Comptex Textiles Ltd. (New Building)

Vulta, Rupgonj, Narayangonj
(23.771919N,90.560803E)
16th February 2017

Observations

Hairline crack on slab

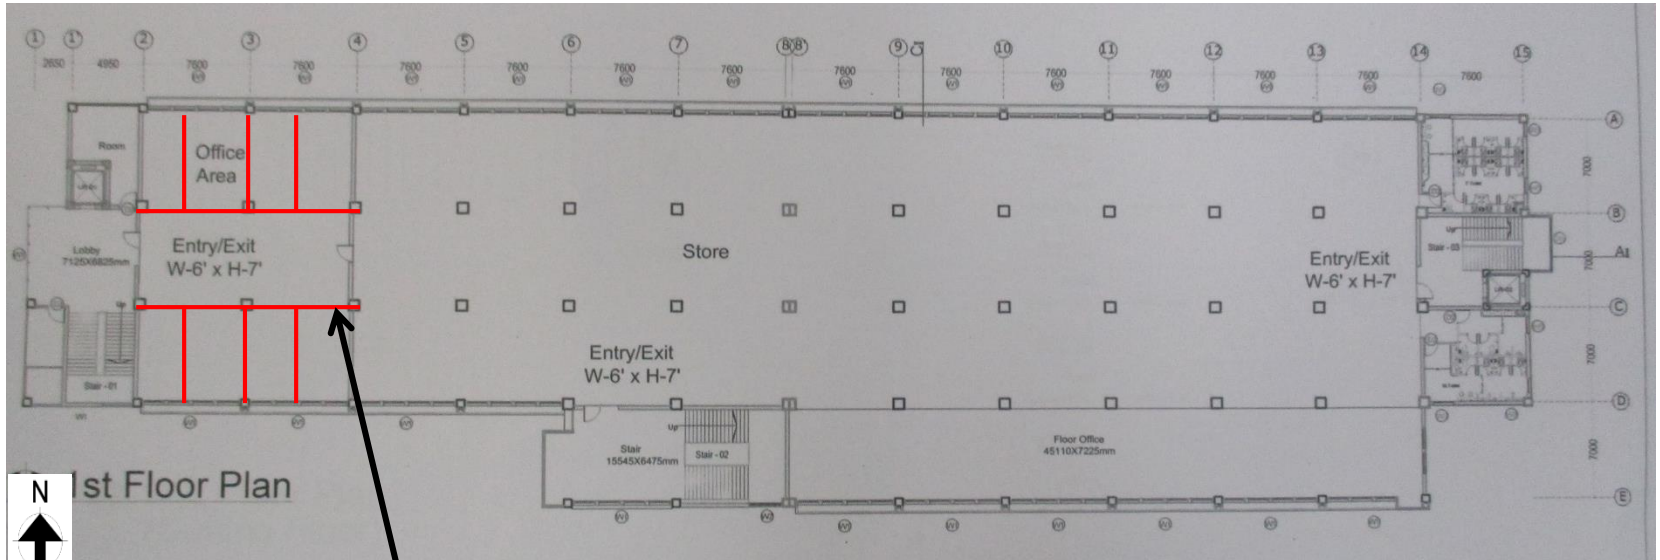
Hairline crack appeared on ground floor slab on top surface at several locations. Building engineer to investigate the extend of cracks and check the capacity of slab against existing floor load.
